LiDAR Quality Assessment Report

UT_Ogden-FEMA

LiDAR generated point cloud acquired in October 2011 for a 116-square mile area encompassing Ogden UT.

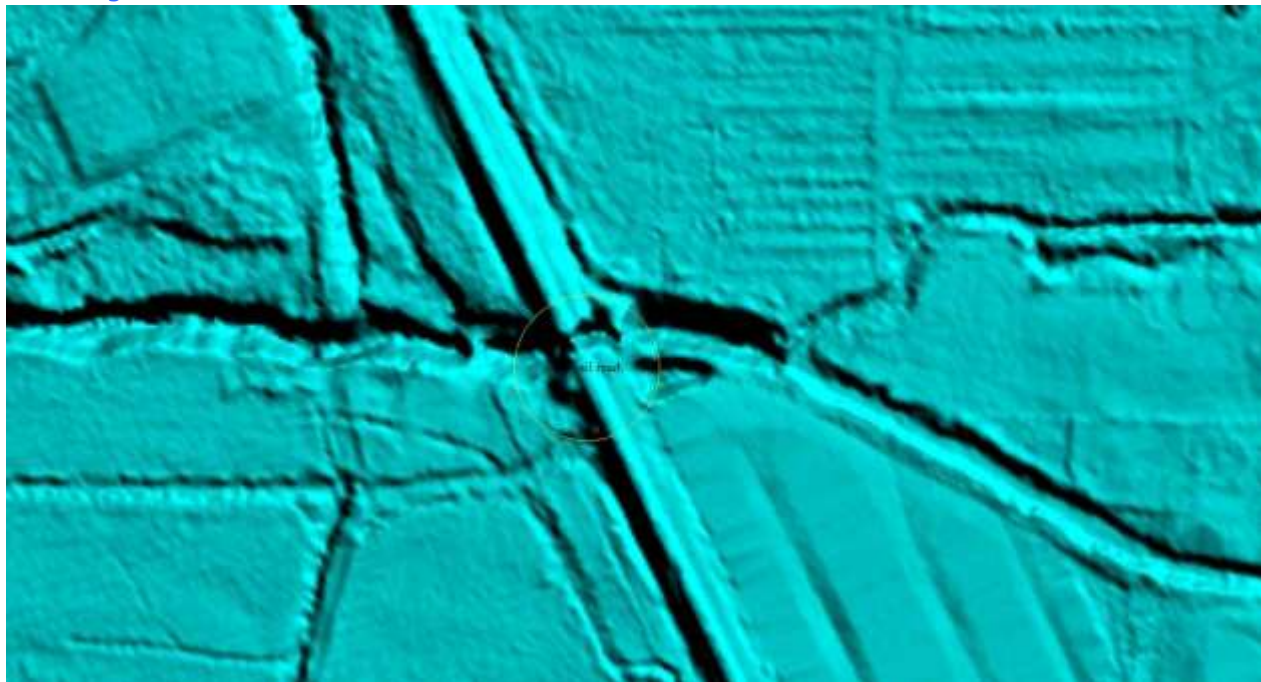
Rail road not fixed by the contractor

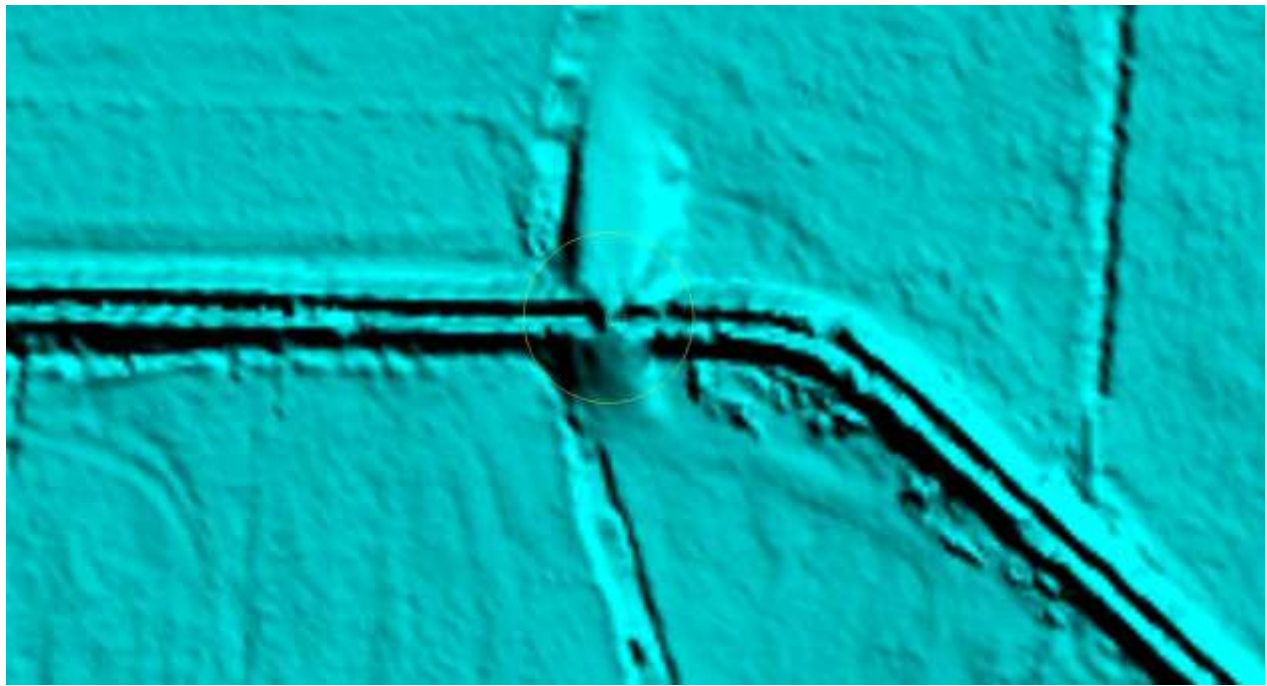
Road not fixed by the contractor

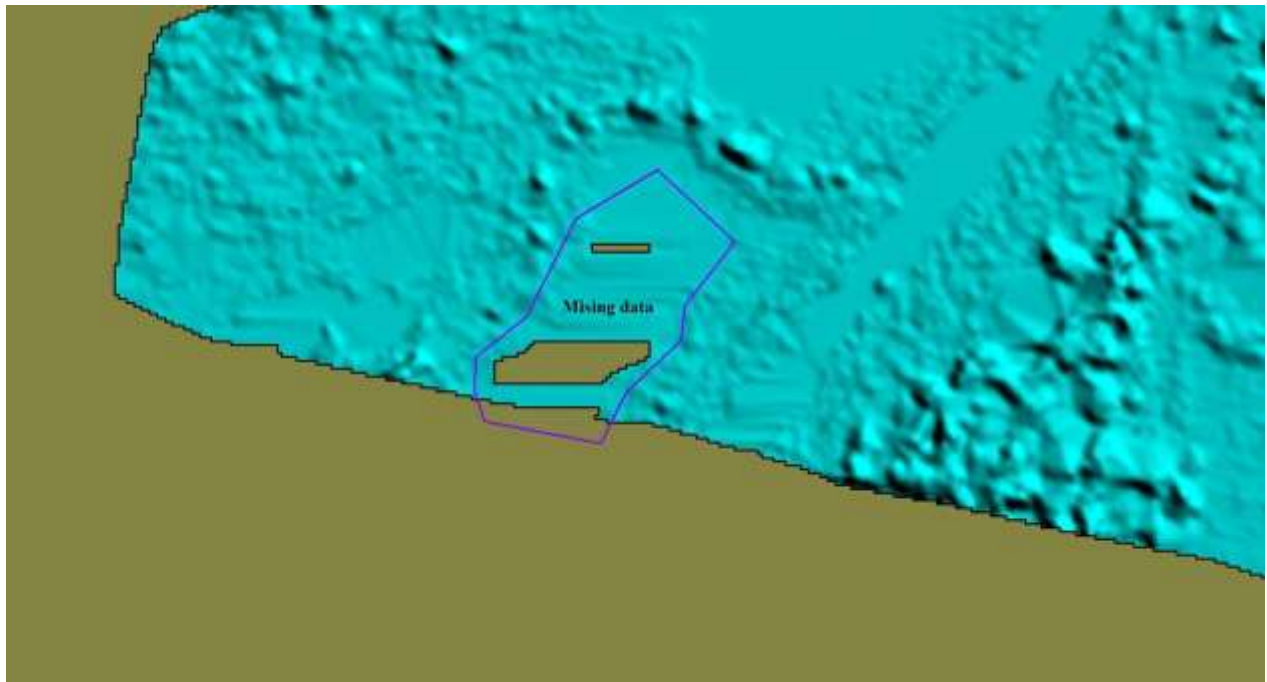
Missing data not fixed by the contractor

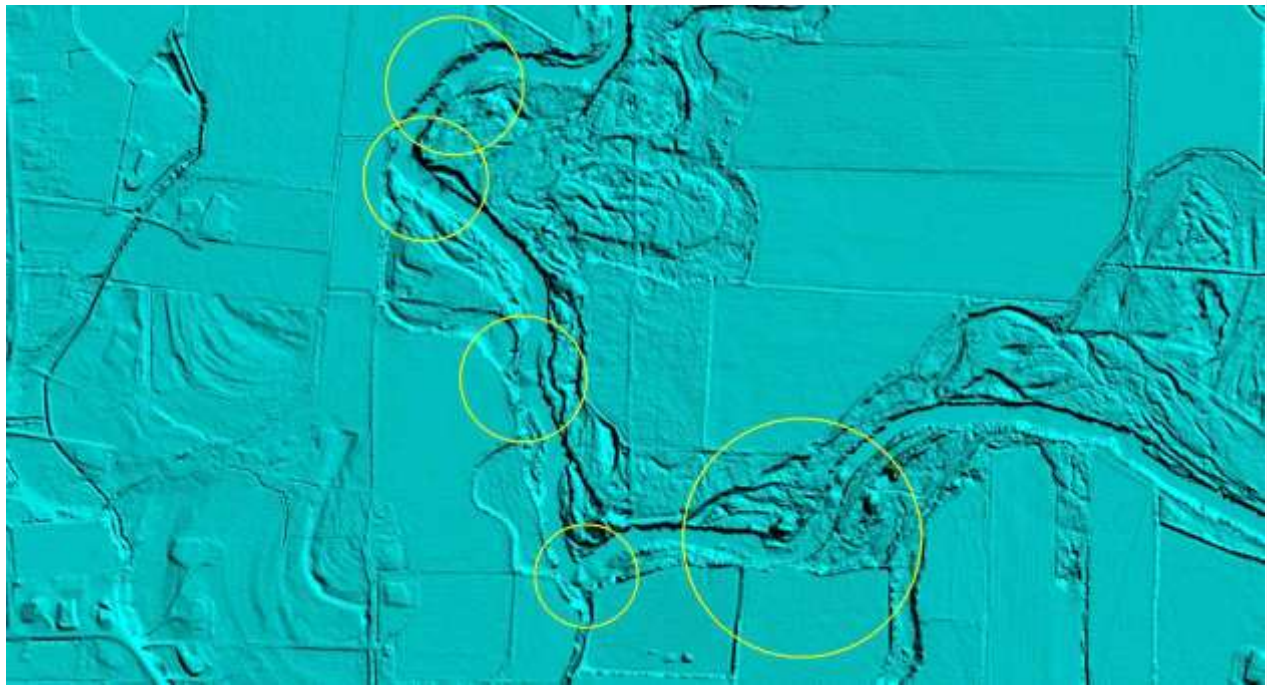
River errors fixed by the contractor

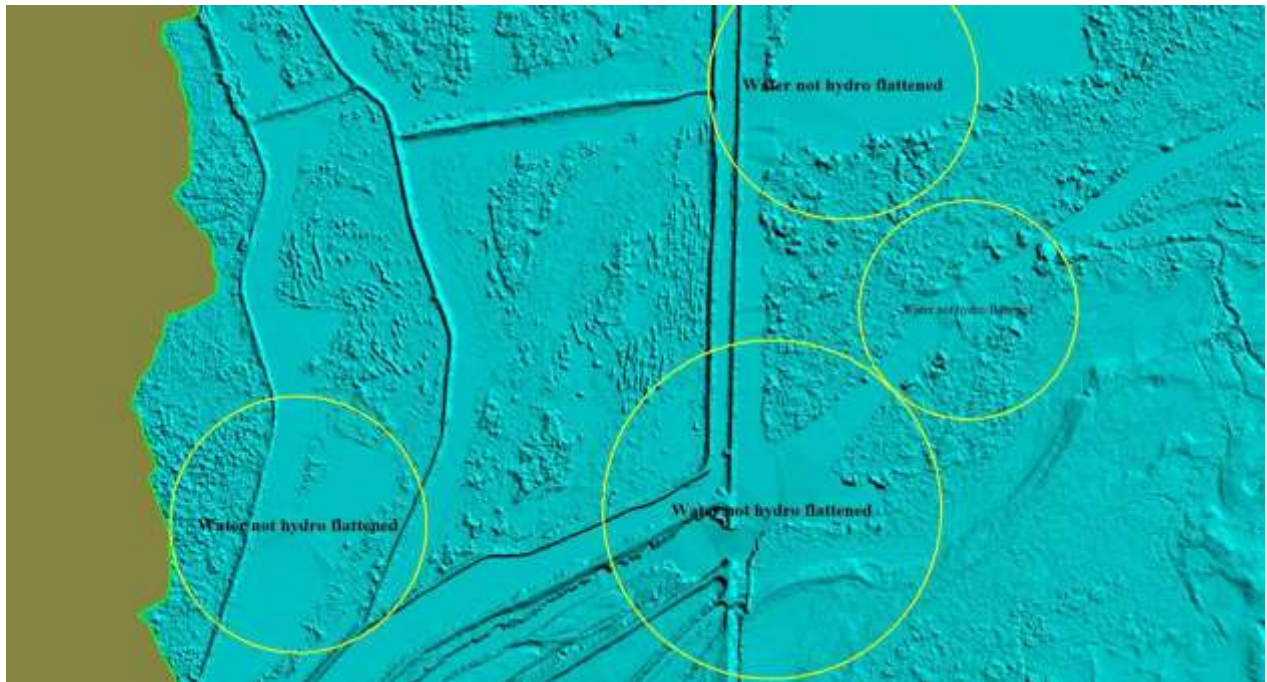
River errors fixed by the contractor
